ADDENDUM NO. 2
to the
PROJECT DOCUMENTS AND SPECIFICATIONS
for
T-HANGAR DEVELOPMENT

AVCON Project No. 2022.0241.01

Addendum Date: November 7, 2024

ADDENDUM NO. 2
T-HANGAR DEVELOPMENT
Calhoun County Airport

NOTES:

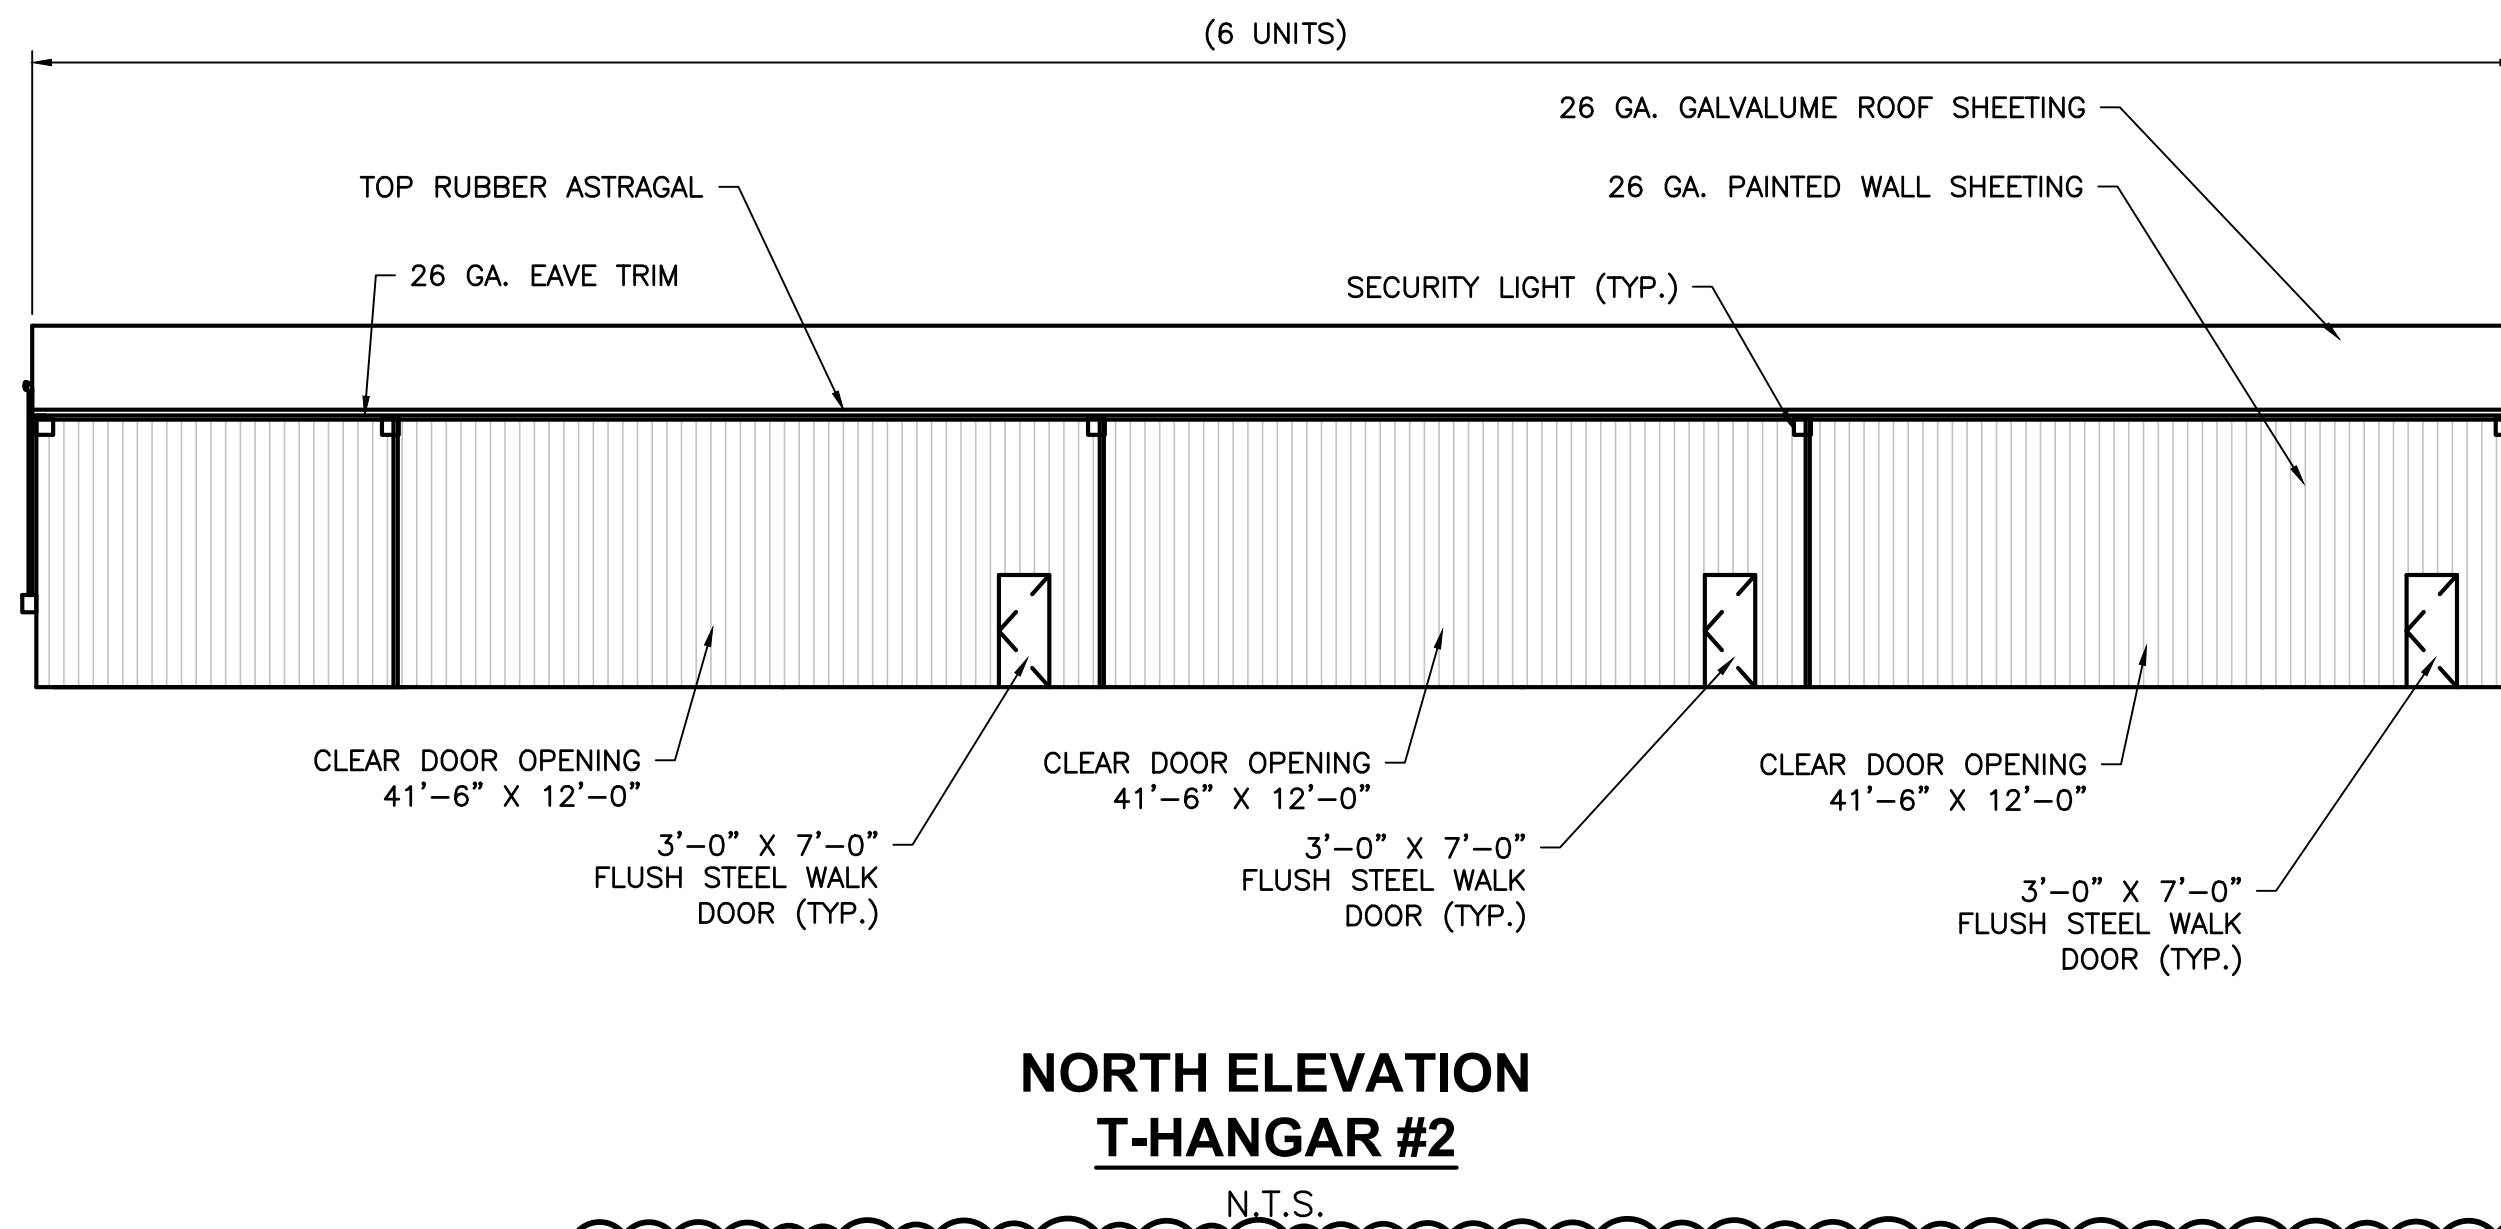
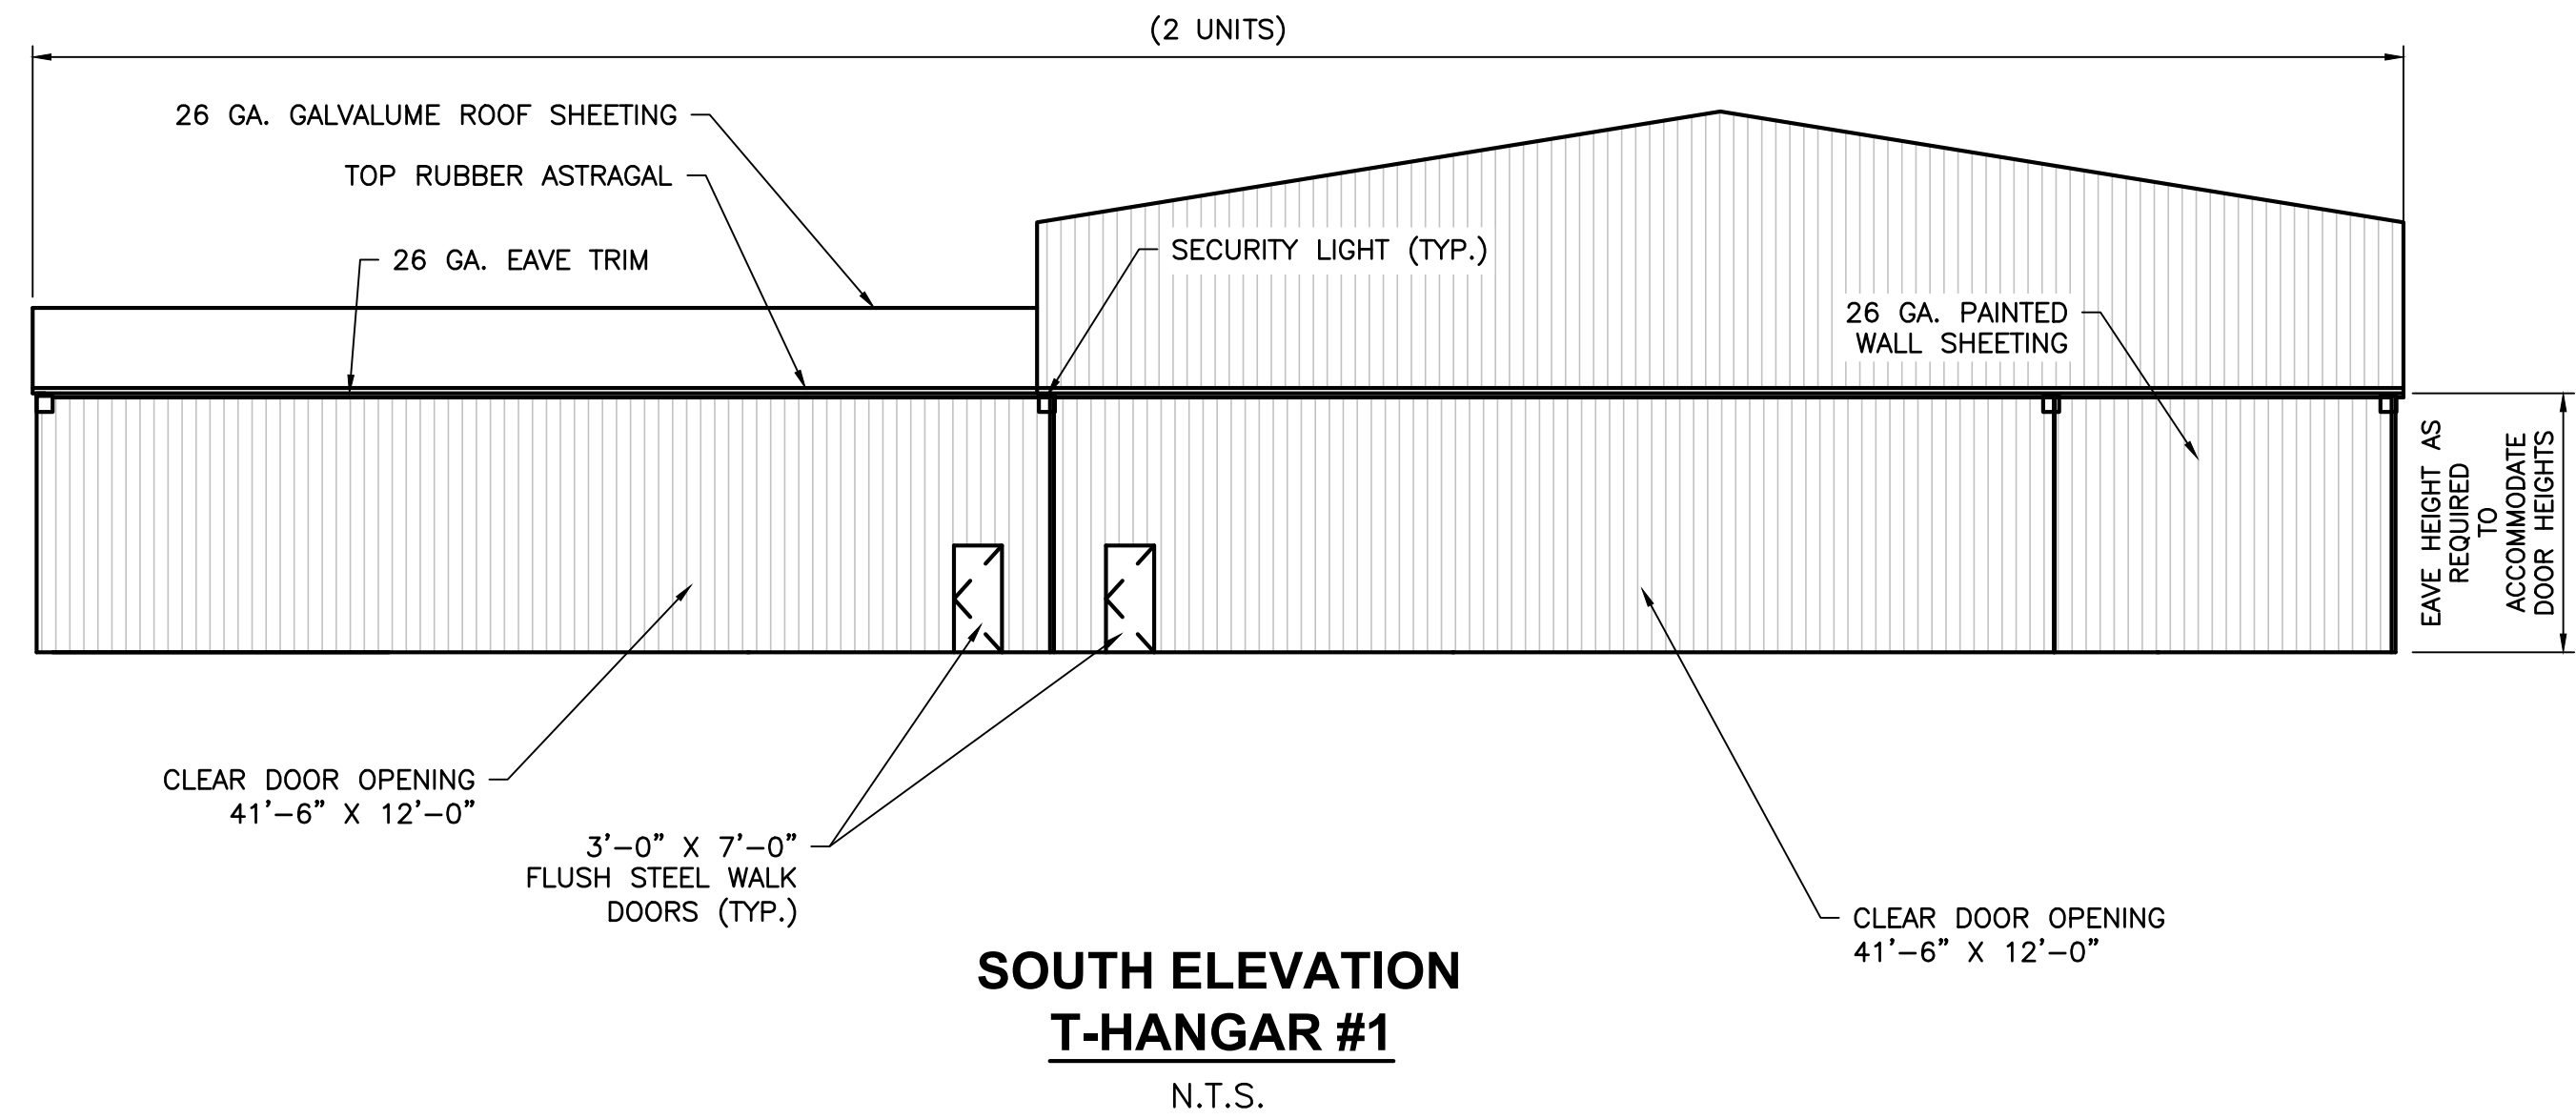
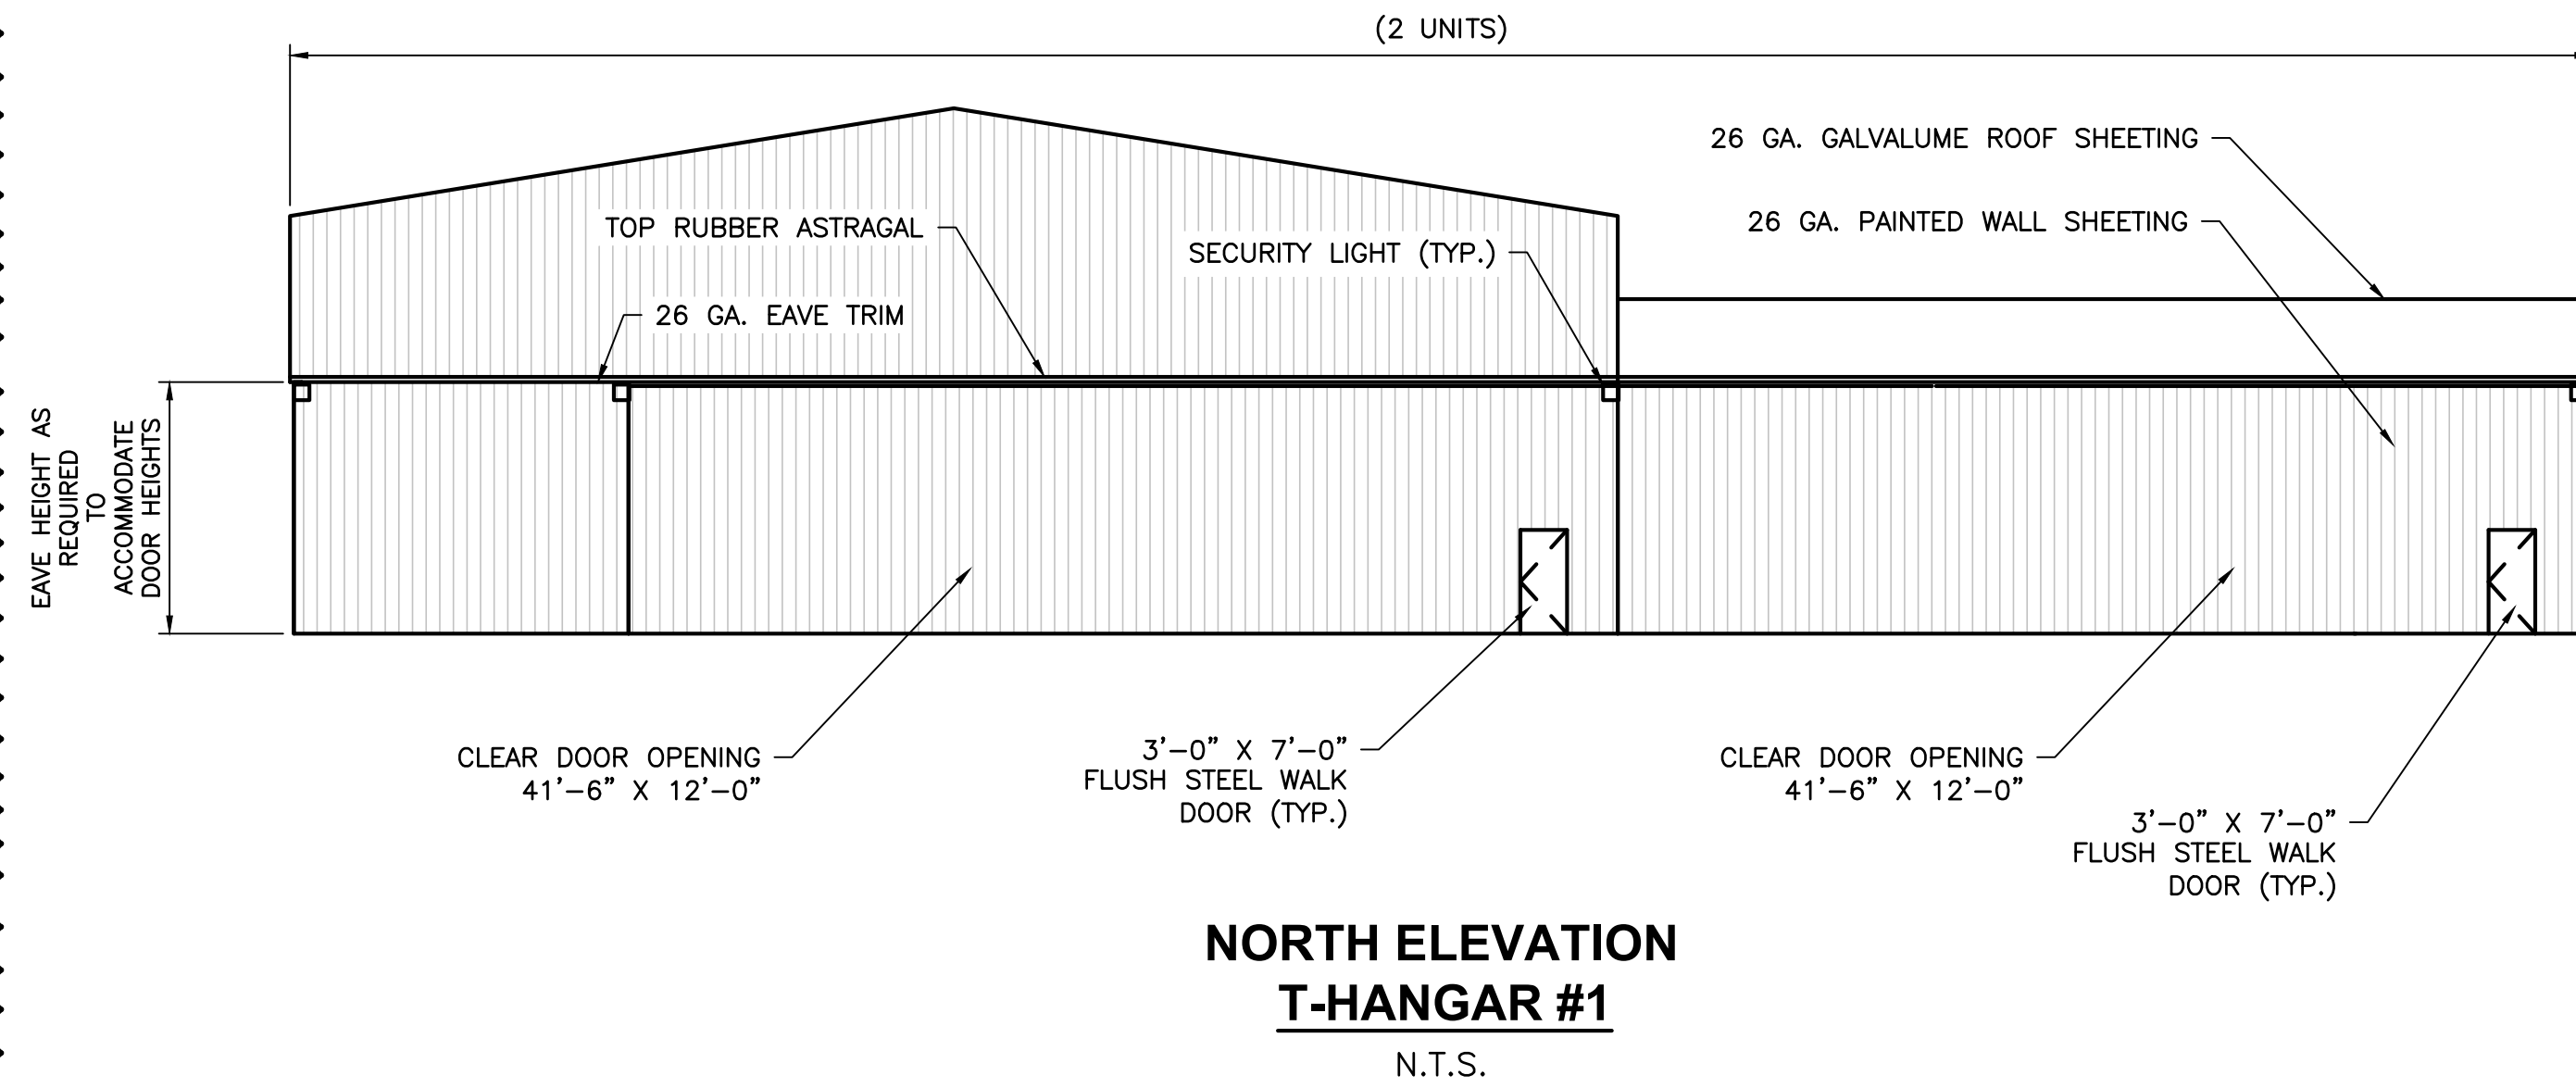
RESPONSE: Correct, the design of the T-Hangar foundations are the responsibility of the contractor per the requirements provided on Sheet C-6 and C-8 and Technical Specification H-100, Section 2.10(b). Addendum No. 2 clarifies that the minimum foundation slab thickness is 8 inches.

RESPONSE: The roof elevation and ridge orientation for the large open area in Hangar #1 have been revised in Addendum No. 2 to allow the load bearing walls to run north-south over the large open area. This should allow the clear open area depicted on Sheet C-6 without requiring interior columns. The tail section widths will be revised to 22 ft in Addendum No. 2.
